**STAFF REPORT: APPEAL**

APPEAL NO.: **A-1-MEN-07-043**

APPLICANT: **Gualala Community Services District**

PROJECT DESCRIPTION: Extension of a 6-inch diameter wastewater main approximately 1.25 miles (~6,500 feet) within the County road right-of-way from an existing Gualala Community Services District system to serve a proposed school in Gualala.

<b>EXHIBIT NO. 4</b>
APPEAL NO. A-1-MEN-07-043
GUALALA COMMUNITY SERVICES DISTRICT
URBAN/RURAL BOUNDARY MAP

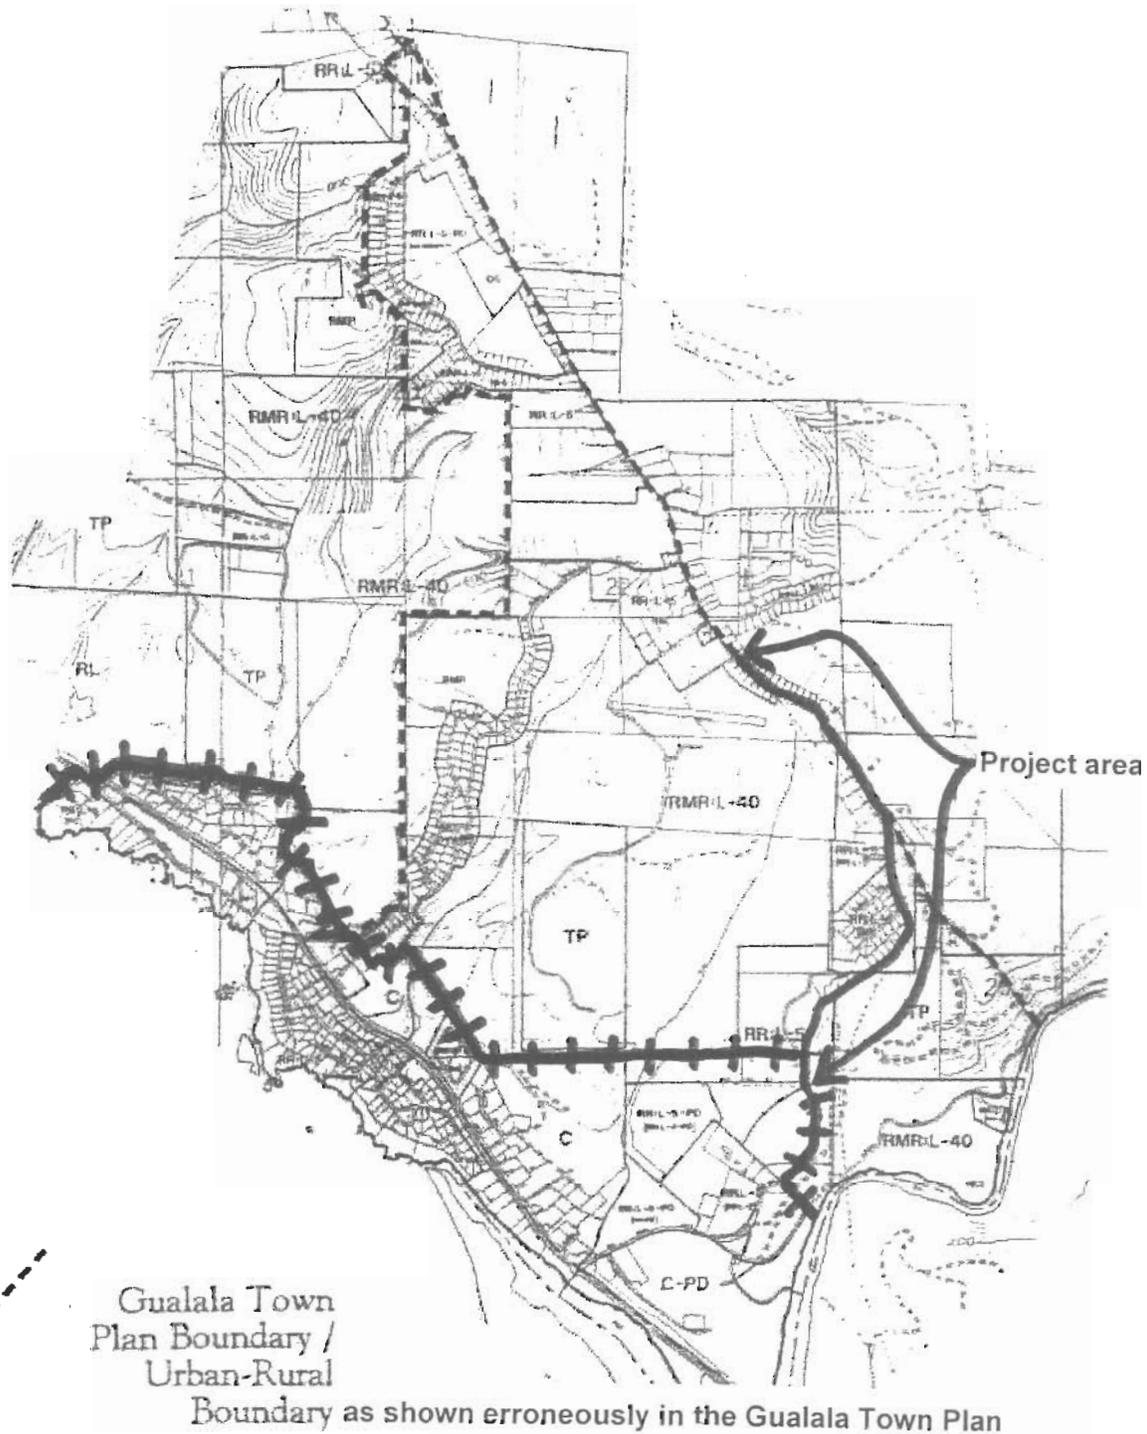
development in the Gualala area shall be concentrated within the urban side of the urban-rural boundaries, where it can be served by community sewer systems. The approved development is located outside of the urban-rural boundary, as seen on Exhibit No. 4. According to LUP Policy G3.1-1, the urban-rural boundary is coincident with the boundary lines drawn on Land Use Map 31. The Gualala Town Plan (Figure 1.1, reproduced in Exhibit No. 4) erroneously depicts the urban/rural boundary as being coincident with the Gualala Town Plan area boundary, which extends much further inland than the actual boundary. [Prior to the filing of this appeal, Commission staff was not aware of the map error in the Gualala Town Plan.] This error presumably resulted from the County's proposal, in 1998 under LCP major amendment number 2-98, to expand the urban/rural boundary to encompass the entire Gualala Town Plan area. However, because of concerns regarding the limited capacity of the sewer system, the Commission approved the LCP amendment with several Suggested Modifications, two of which (Suggested Modification Nos. 15 and 16) required the urban/rural boundary to remain coincident with the previously designated boundary lines delineated on Land Use Map 31 rather than moved to the County's proposed expanded boundary shown on Figure 1.1 of the Gualala Town Plan (see Exhibit No. 4). Thus, the approved development would expand the community sewer system outside of the urban-rural boundary, which would allow for development in rural areas inconsistent with LUP Policy G3.1-2.
